RE: JMC Project 19124
#100-Building 2
100 Business Park Drive
Town of North Castle, NY

Response to Town Comments Submission

Town of North Castle Planning Department Memorandum, dated April 10, 2020

**NORTHERNMOST LOADING DOCK
WB-67 ENTERING MOVEMENT**

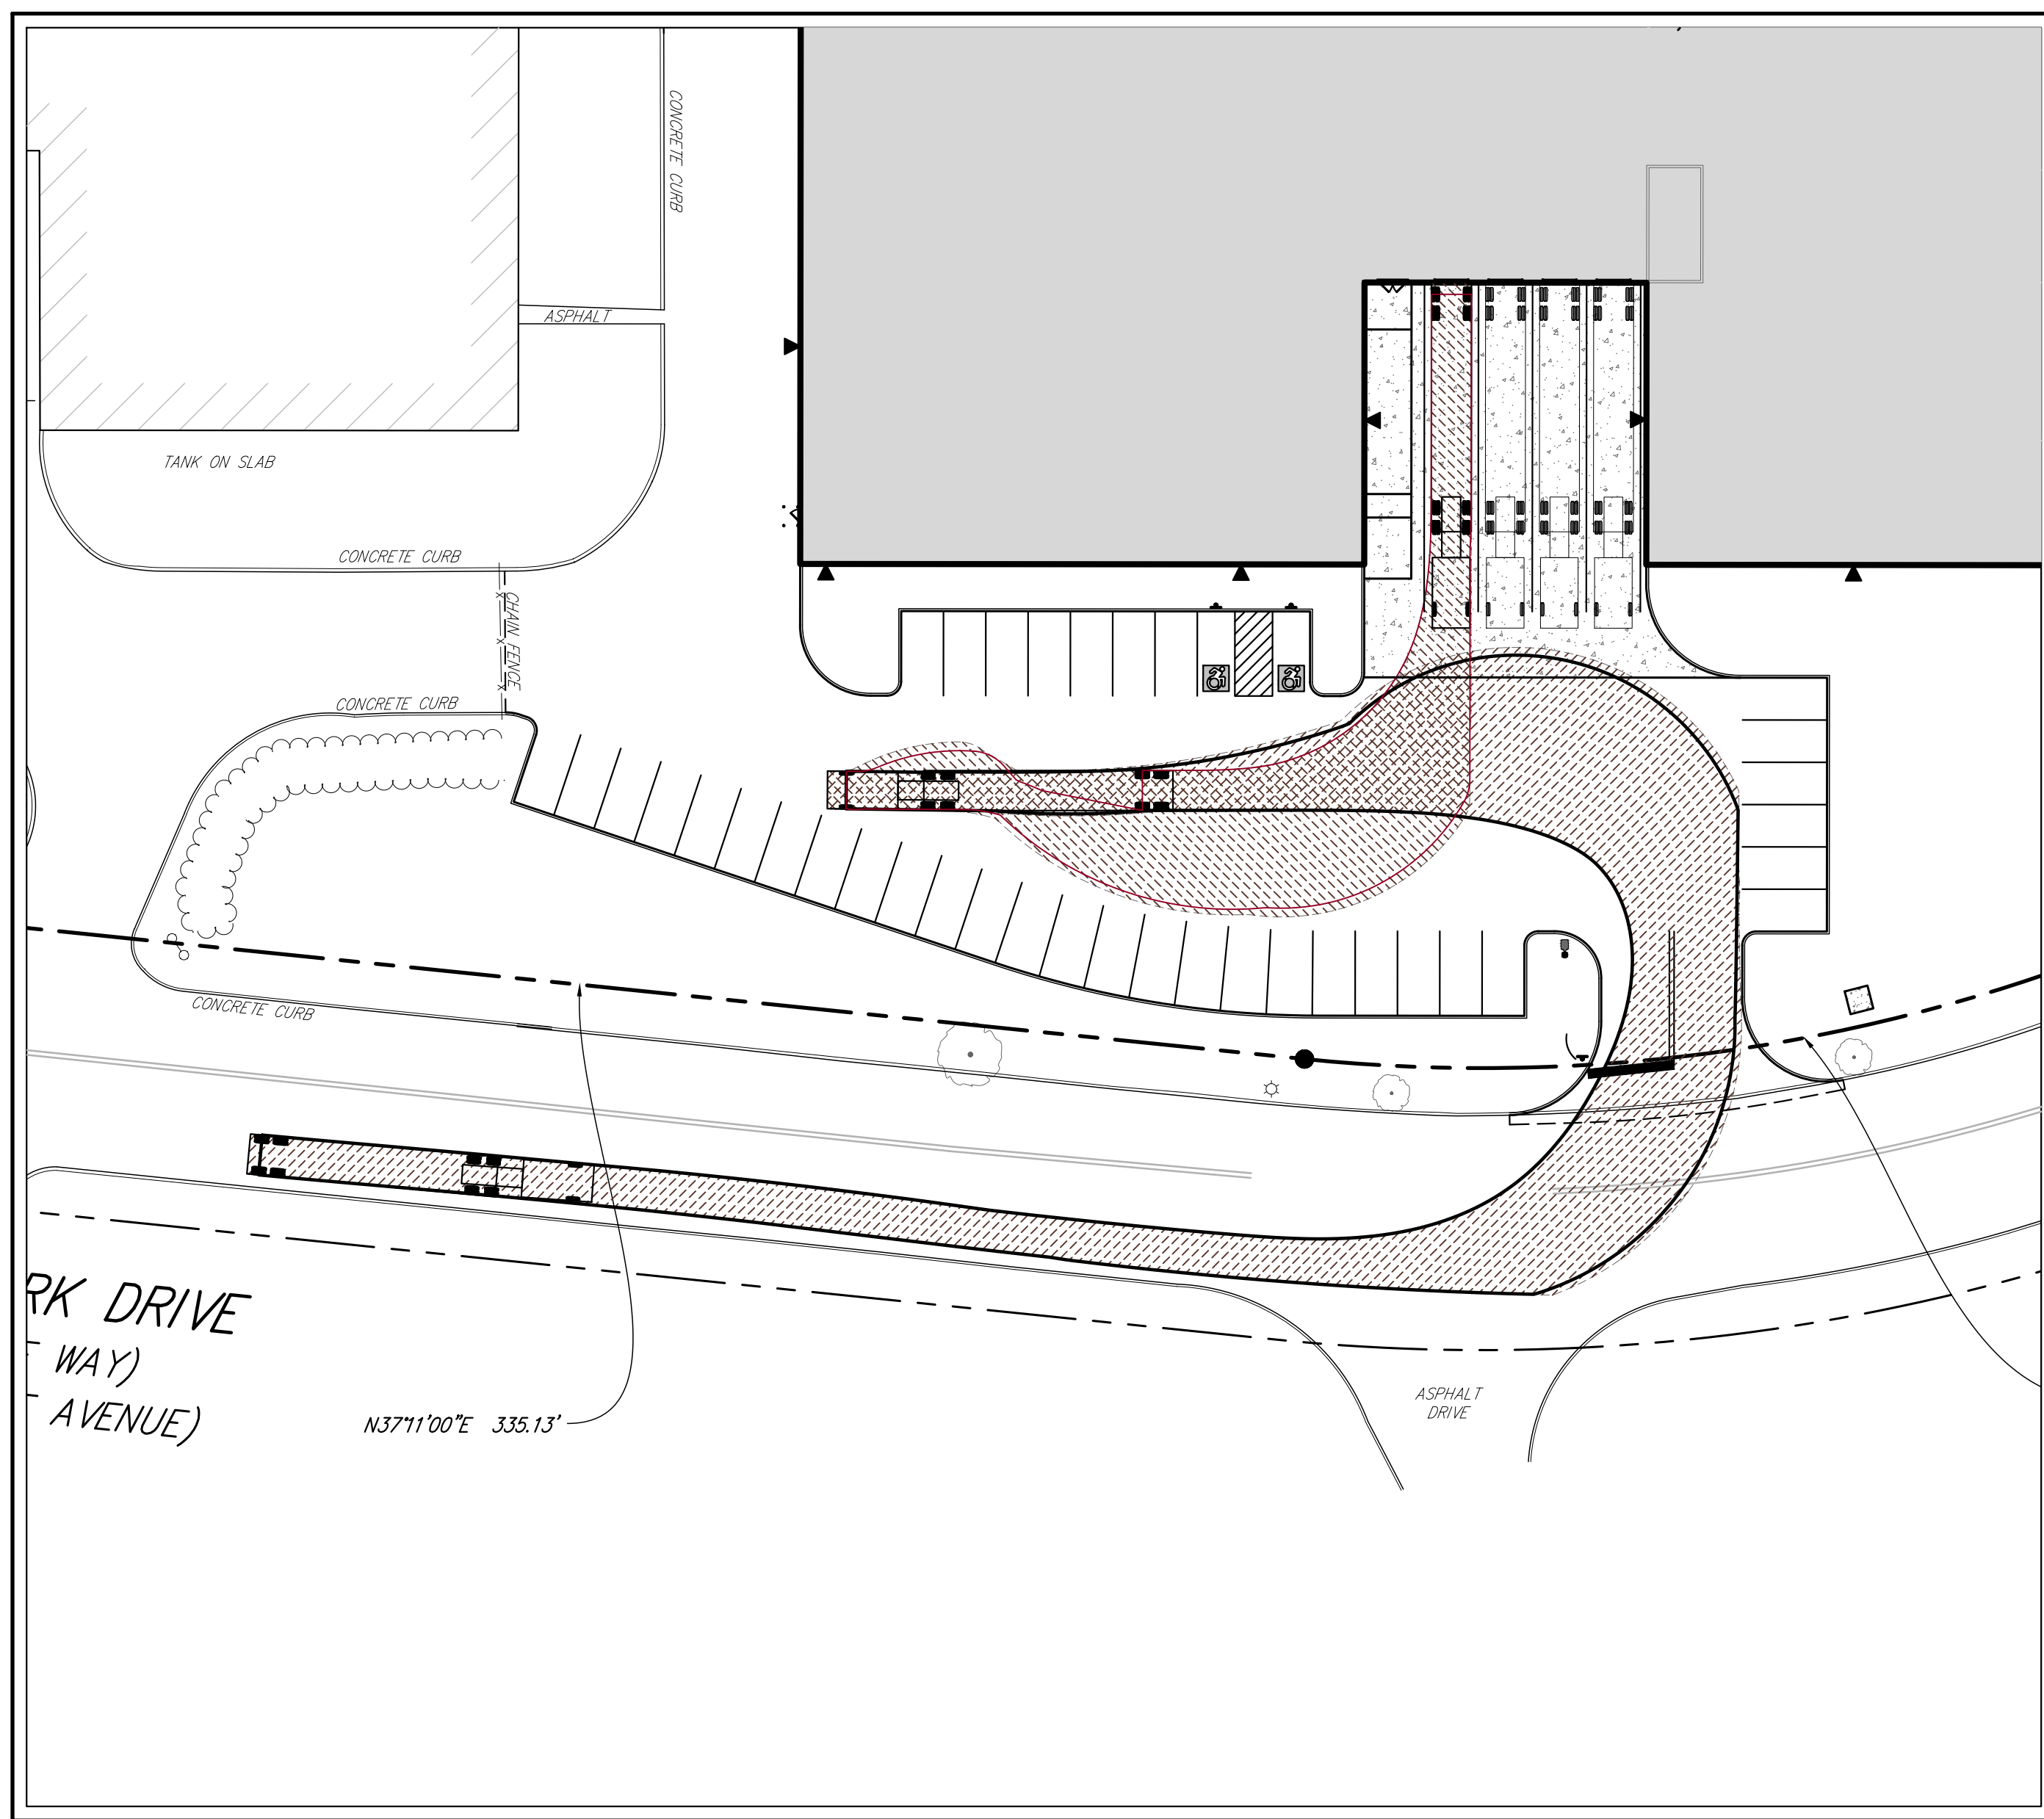
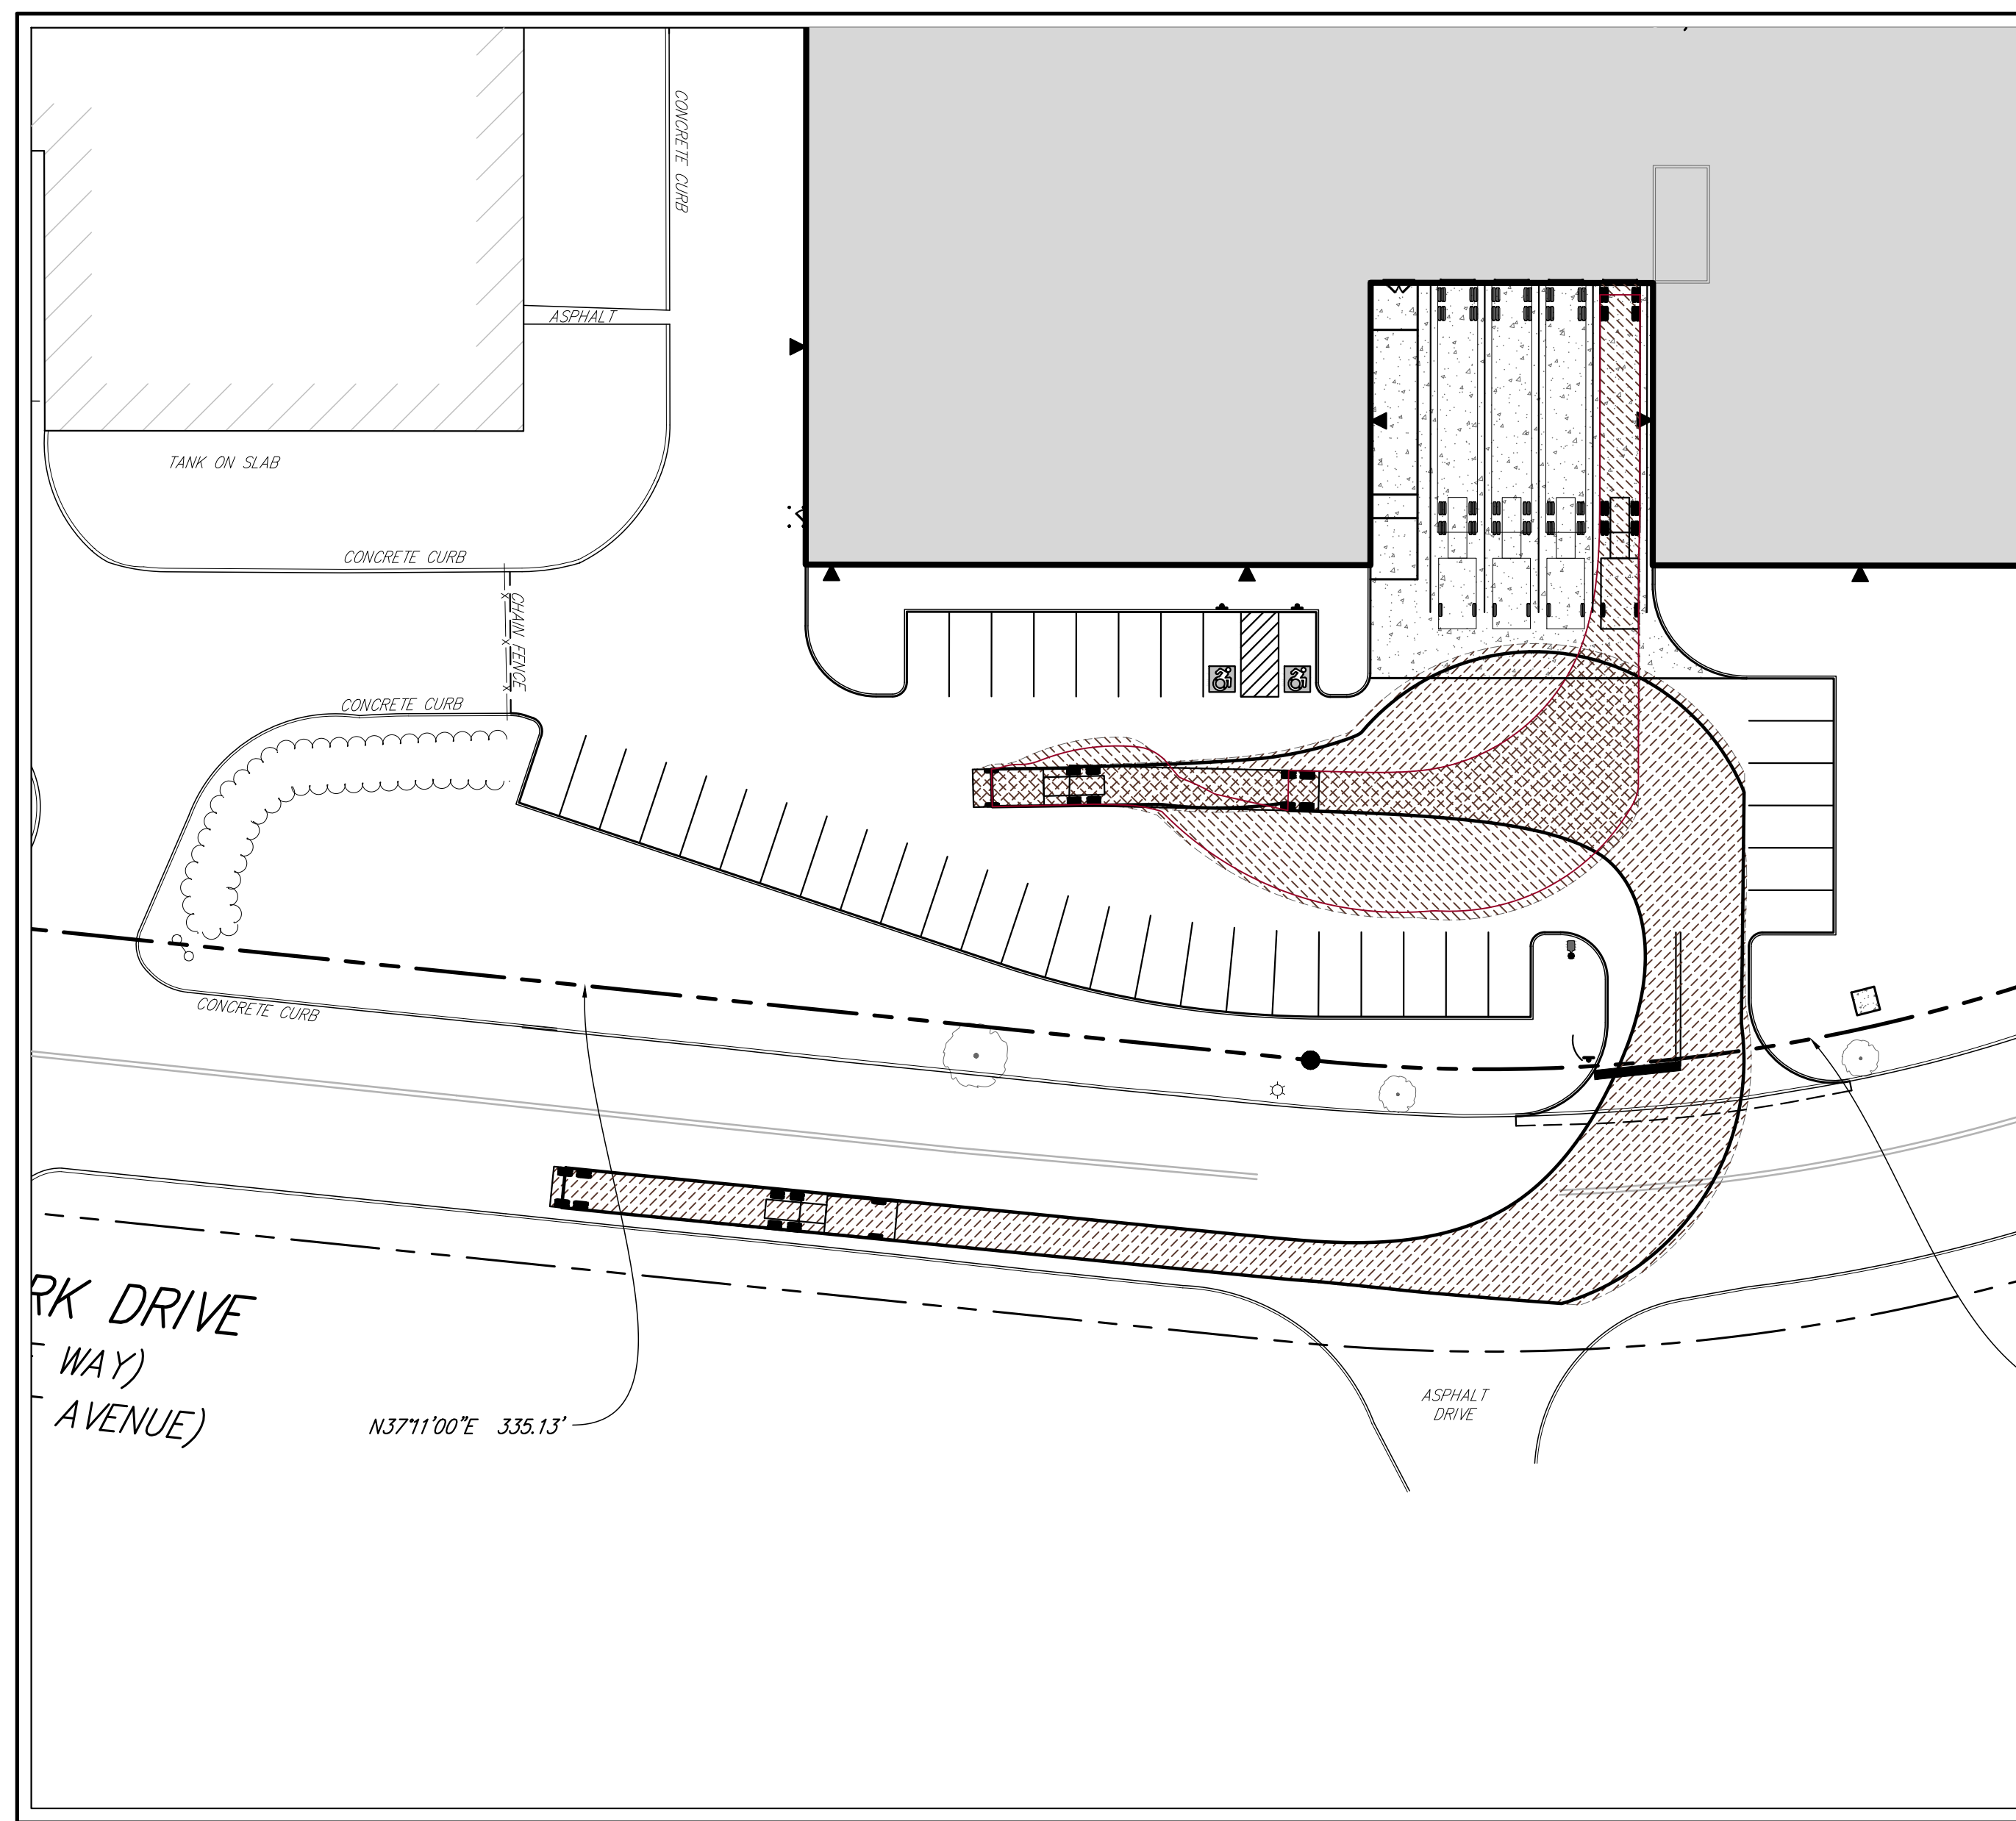
The plan proposes a total of eight (8) loading docks at the front of the proposed warehouse building, four (4) of which are shown as tandem spaces. The applicant should provide vehicle turning movements for the size trailer anticipated to access the site to demonstrate adequate maneuverability into the site and accessing these loading areas.

The site plans have been revised to depict delivery truck (WB-67) vehicle turning analyses demonstrating adequate maneuverability into the site and accessing the loading areas.
